## Appendix Q

### Community Participation and Comments

## Public Comments

Several comments were addressed to the DC Office of Planning regarding the OP's draft UWACS plan. The Wisconsin Avenue Corridor Transportation Study (WACTS) Study Team reviewed all of the comments received including comments specifically to the draft UWACS plan. Comments unrelated to the Wisconsin Avenue Corridor Transportation Study were not included in this appendix.

## Exhibit 1: Summary of Development Scenario Descriptions

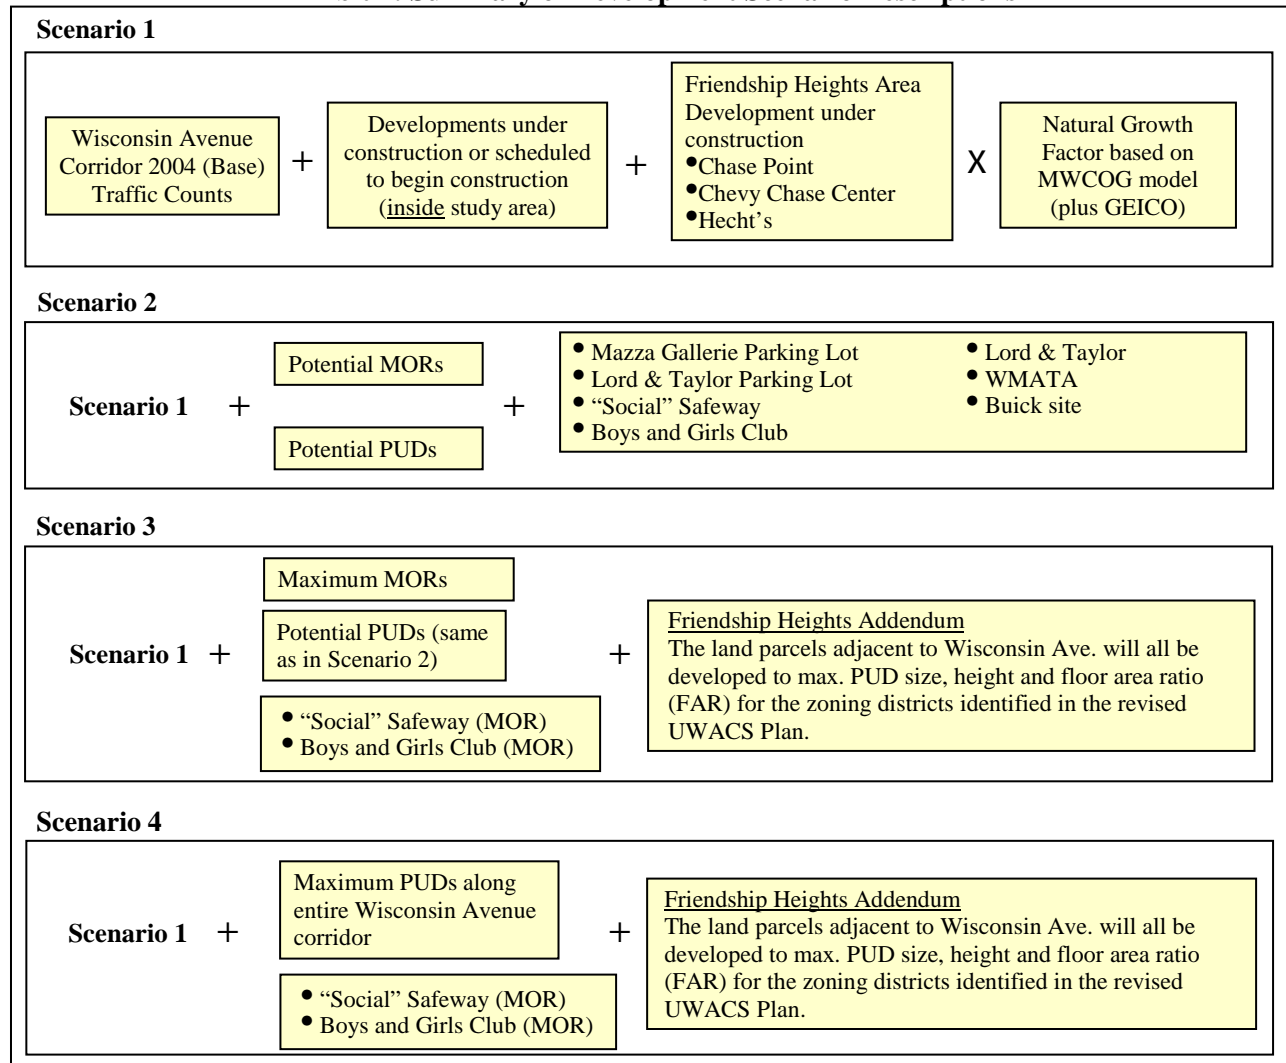
We appreciate this commitment, but the revised Development Scenarios which accompanied this response did NOT reflect this change. See, for example, Exhibit 1 on page 2, the charts on page 3, and the descriptions of Scenario 3 and Scenario 4 on page 6.

**We appreciate this commitment, but the revised Development Scenarios which accompanied this response did NOT reflect this change.** See, for example, Scenario 2 on page 5 and Scenarios 3 and 4 on page 6, as well as Exhibit 1 on page 2.

Further, while we appreciate this commitment to change Scenario 3, the revised Development Scenarios which accompanied this response did NOT reflect this commitment. See Scenario 3 on page 6, as well as Exhibit 1 on page 2. See, also Scenario 4, where the same change is necessary.
